Office Action Summary

10/033,883

YAO ET AL.

DETAILED ACTION

Figure 9 of the Klein Patent (US_4,554,460) is shown above.

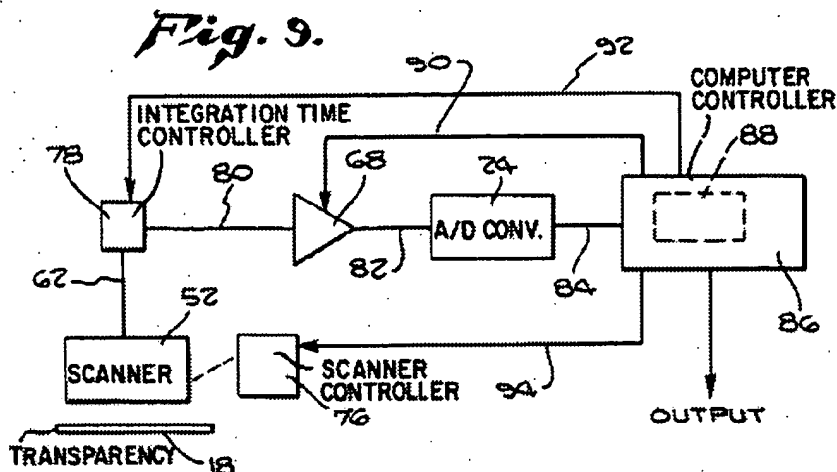
Klein discloses a scanning analyzer unit comprising:

A). A scanning processor unit 52 that scans the testing support 18, wherein the scanning processor unit 52 outputs a test signal 62 resulting from the scan of the testing support 18 (see Figure 9);

a signal amplifier 68 that is coupled with the scanning processor unit 52 to amplify the test signal 62, 80;

an analog/digital converter 24 that is coupled with the signal amplifier 68 and the computing unit 86, wherein the analog/digital converter 24 converts the amplified test signal 82 into a digital signal 84 that is transferred to the computing unit 86;

a computing unit 86 (see col.5, line 21) that is coupled with the scanning processor unit 52, wherein the computing unit 86 receives and analyzes the test signal 62;

a controller device 86 that is coupled with the scanning processor unit 52, wherein the controller device 86 outputs a driver signal 94; and,

a driver device 76 that is coupled with the controller device 86 and the scanning processor unit 52, wherein the driver device 76 receives the driver signal and accordingly drives the scanning processor unit 52 to accomplish the scan of the testing support 18 (see col. 5, lines 10-30), the scanning analyzer used for analyzing testing results that are obtained from a testing support for determining spectral quality of a sample under test (see col. 1, lines 6-31).

However, Klein does not teach of a scanning analyzer apparatus comprising separate computing unit and controller device for analyzing the test signal from the scanning processor unit and controlling a driver device based on the scanning processor unit output, the scanning analyzer apparatus used for analyzing testing results that are obtained from a testing support for determining spectral quality of a sample under test.

B). Klein teaches of a scanning analyzer apparatus comprising a combined computing unit and controller device 86 for analyzing the test signal from the scanning processor unit 52 and controlling a driver device 76 based on the scanning processor unit output 62 (see Figure 9; see col. 5, lines 10-30), the scanning analyzer apparatus used for analyzing testing results that are obtained from a testing support for determining spectral quality of a sample under test.

C). In view of Klein's teaching, it would have been obvious to one of ordinary skill in the art at the time the invention was made to modify Klein's apparatus by having a separate computing unit and a controller device due to the fact that such separate computing and controlling units would provide a modular system where each module can easily be replaced for repair and/or maintenance of the scanning analyzer apparatus, used for analyzing testing results that are
